AFFIDAVIT OF CORRECTION

To correct certain dimensions of Lots 2 and 4, and Southport Parkway Right-of-way and also Curve 1 in the Center-line Curve Table, Southport East (Lots 1 thru 16 Inclusive and Outlot "A"), a subdivision located in the East 1/2 of Section 16, and also in the NW 1/4 of Section 17, all located in Township 14 North, Range 12 East of the 6th P.M., Sarpy County, Nebraska.

AFFIDAVIT OF CORRECTION  
LOTS 2 AND 4, AND SOUTHPORT PARKWAY RIGHT-OF-WAY,  
SOUTHPORT EAST  
(LOTS 1 THRU 16 INCLUSIVE AND OUTLOT "A")  
SARPY COUNTY, NEBRASKA

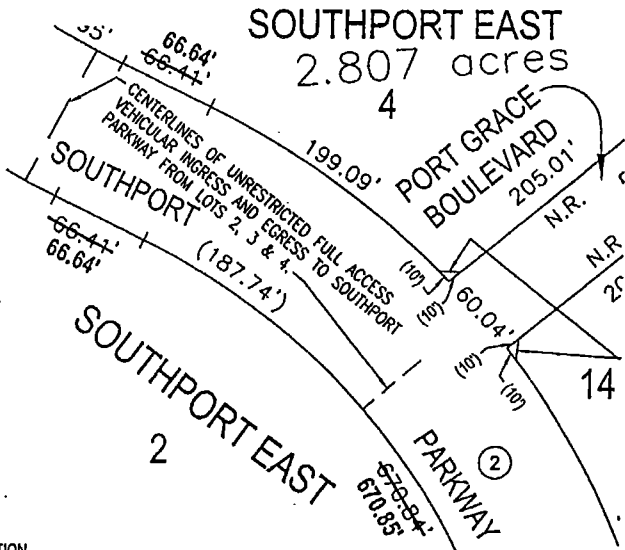
- The Northeasterly line of said Lot 2 to read 66.64 feet instead of 66.41 feet.
- The Southwesterly Right-of-way line of Southport Parkway to read 66.64 feet instead of 66.41 feet.
- The Northeasterly line of said Lot 4 to read 670.85 feet instead of 670.84 feet.
- The Southwesterly Right-of-way line of said Southport Parkway to read 670.85 feet instead of 670.84 feet.
- The Southwesterly line of said Lot 4 to read 66.64 feet instead of 66.41 feet.
- The Northeasterly Right-of-way line of said Southport Parkway to read 66.64 feet instead of 66.41 feet.
- The Curve 1 in said Center-line Curve Table to read Radius - 549.50 feet, Length - 316.08 feet, Tangent - 162.55 feet, Delta - 32°57'26" instead of Radius - 549.32 feet, Length - 315.79 feet, Tangent - 162.39 feet, Delta - 32°56'15".
